RE: Development review Committee Comments October 23, 2018

Comment: M6 - Describe variances you are requesting from Appendix F and how the proposed architecture fulfills the intent of the Overlay Design Standards.

Building 1 - Use: Office - Approximately 8,000 SF office building with a staff of 20-25 office employees

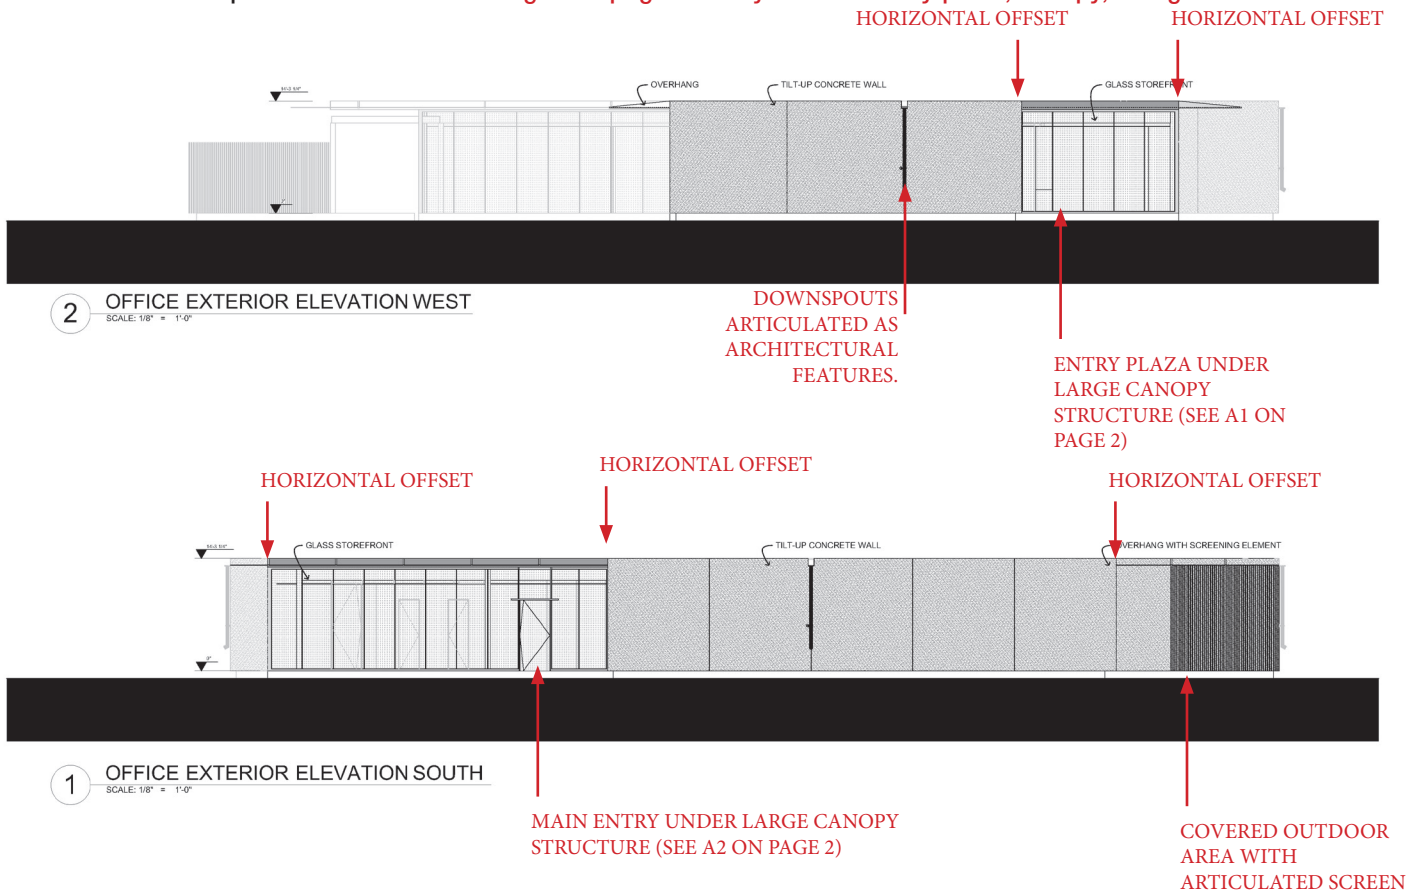
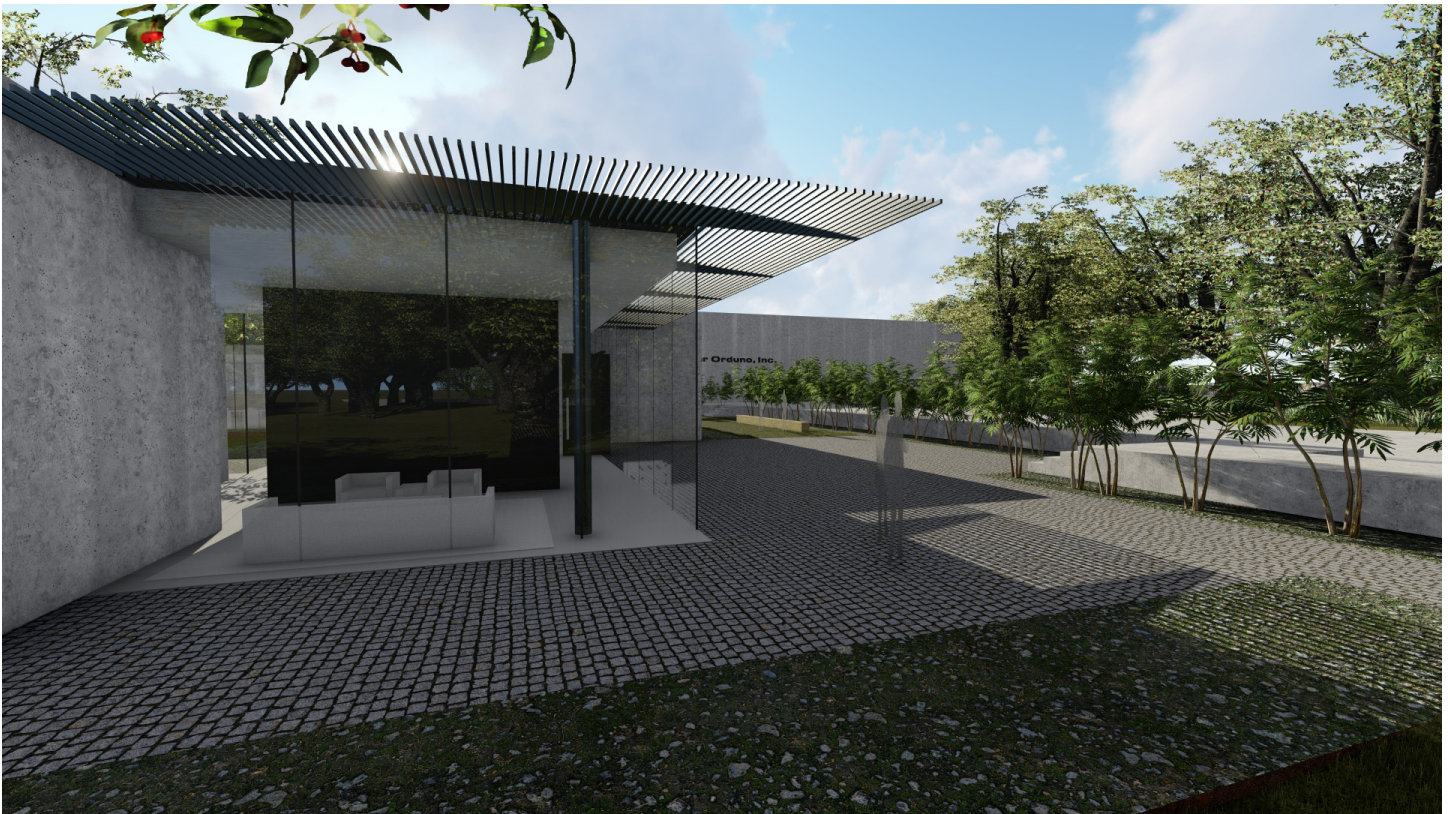
1. 25% stone accent requirement; Primary facade to be combination of tilt-up concrete and glass curtain wall. See page 3 for examples of concrete texture.

2. Vertical and horizontal articulation; Horizontal articulations noted. Variance from vertical articulation requested. Design aims to reduce overall height of building in order to maintain views from the street to live oak trees behind building.

3. Masonry and texture appliques on a minimum 25% of all exposed poured-in-place tilt wall; See page 3 for examples of concrete texture
4. Covered walkways along 50% of the façade length (it is unclear if this requirement is met due to the elevations not being labeled for orientation); Covered entry plaza connecting to parking access. Remainder of facade not typical pedestrian route.

5. Articulated public entrance. See images on page 2. Entry articulated by plaza, canopy, and glass storefront.

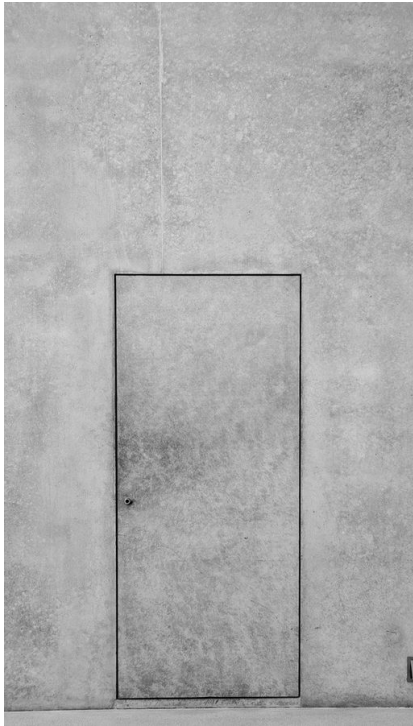
Texture application for the poured in place concrete aims to achieve a purity of material that highlights the natural movement of surface color and texture inherent in concrete construction. Precedent images below.

A3 - VIEW OF WEST FACADE OF SHOP

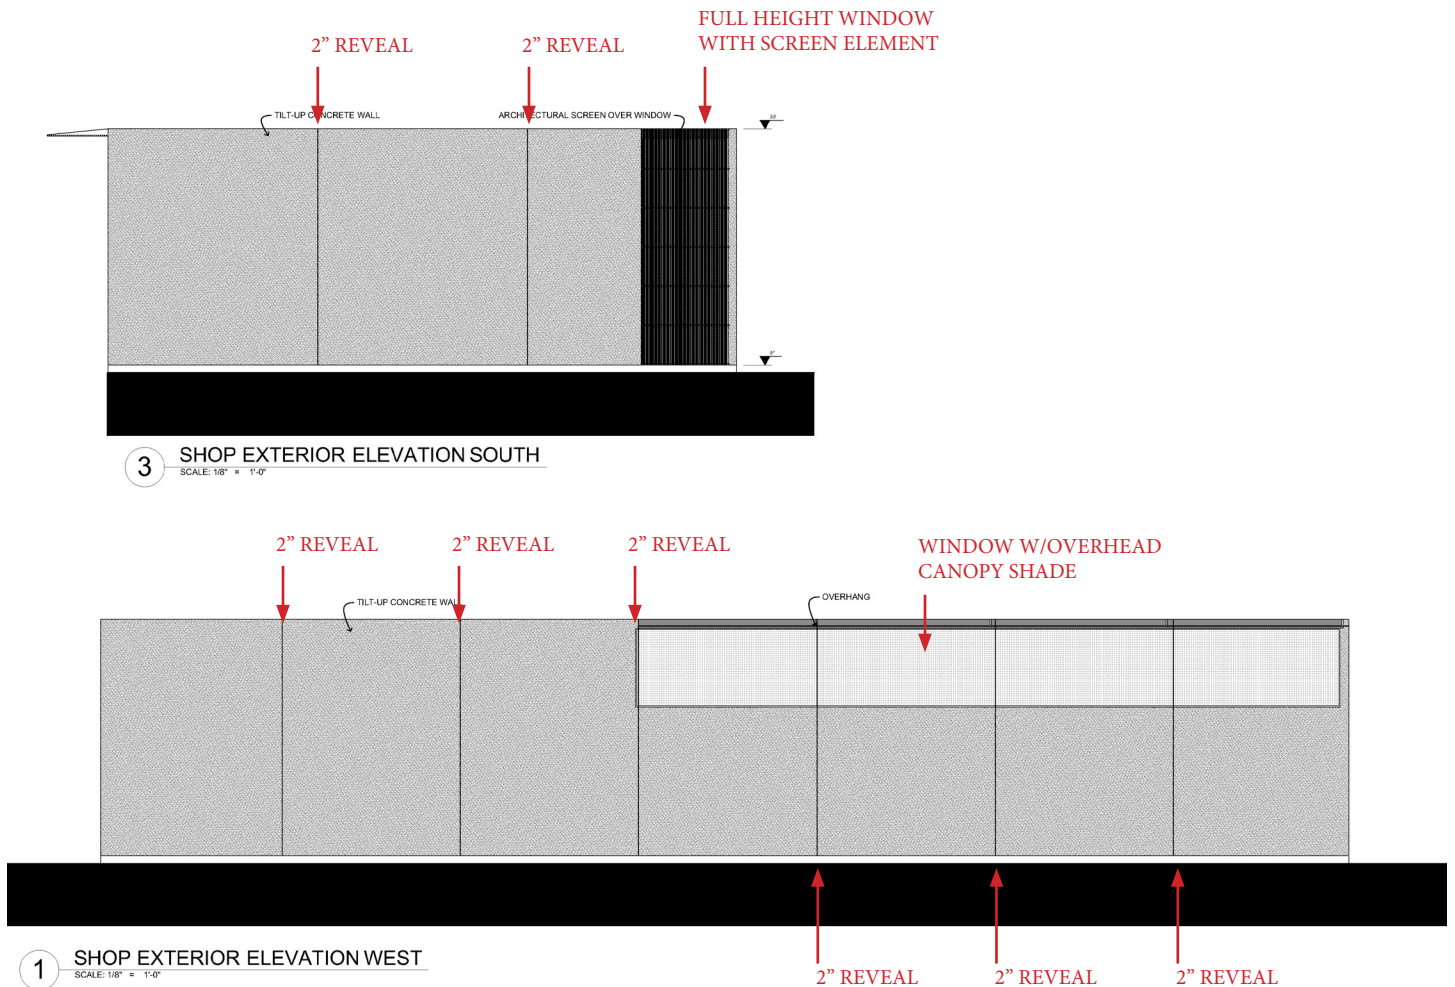
Two or more minor articulation features on west and south facing walls consisting of the following: 2" Reveals (required), surface texture, contrasting paint, panel offsets no less than 8", or panel height changes of no less than 18" **2" Reveals between tilt-up panels shown. Surface texture to match office walls (see page 3)**
